City of Plymouth Planning Commission

Regular Meeting Agenda

**Site Plan Review
For
Plymouth, Michigan**

Subject: PCA Building Expansion – Site Plan Review

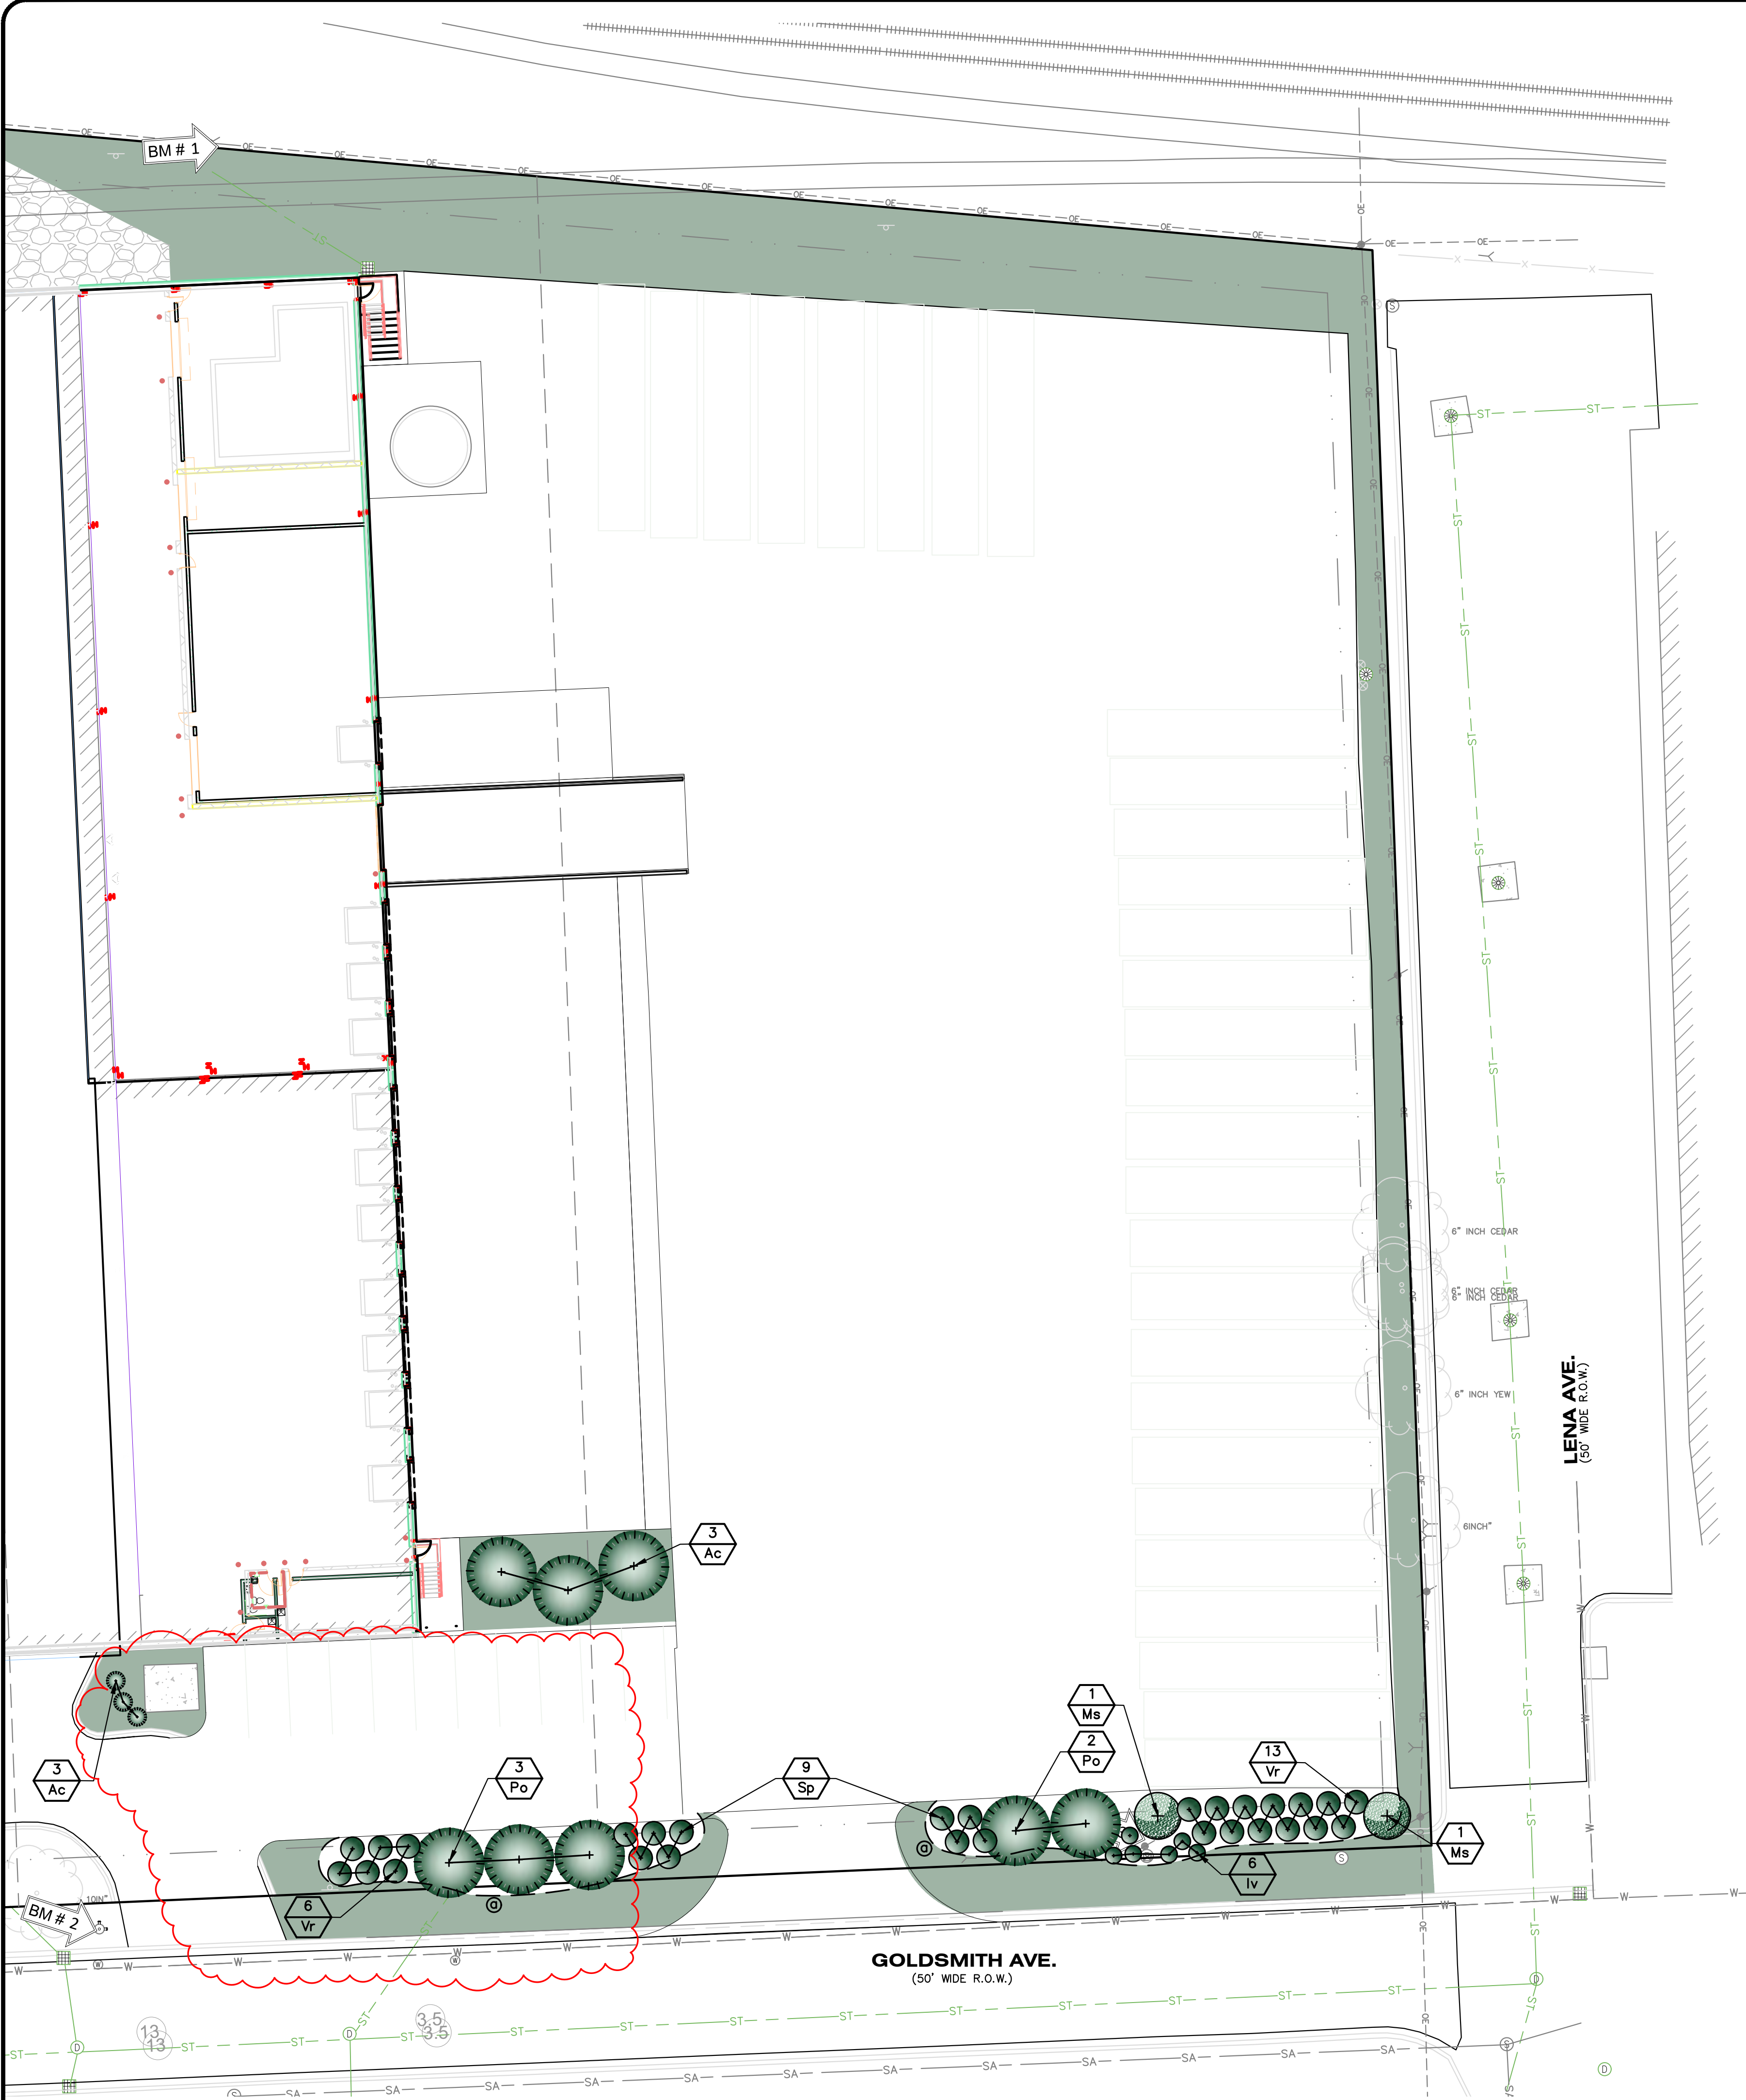
Sheet L-100 shows proposed landscaping along the frontage of the new parking spaces, as well as the trailer parking lot.

The proposed plan shows a mix of deciduous and evergreen material that will accomplish the required screening. The size of the proposed plants meets ordinance requirements. Note that a plant symbol indicates three (3) “Ac”, but this species isn’t in the “Planting Schedule Trees.” It should be added.

The landscape strip is 245 feet long, requiring 8 trees, and 40 shrubs. The strip contains 7 trees, and 34 shrubs. Sec. 78-272(10) states that the Planning Commission may modify the yard screening requirements where, in unusual circumstances, no good purpose would be served by meeting the requirements. We would suggest that the additional three (3) trees labeled “Ac” between the new parking spaces and the loading dock be counted toward the front yard landscaping requirement. We consider the fact that the land uses on the opposite side of Goldsmith Ave. being light industrial uses could justify this modification. The Planning Commission should consider this suggestion.

Items to be Addressed: 1. Add information regarding plant symbol labeled “Ac” to the “Planting Schedule Trees.” 2. Recommend that Planning Commission consider proposed modification to landscaping requirements.
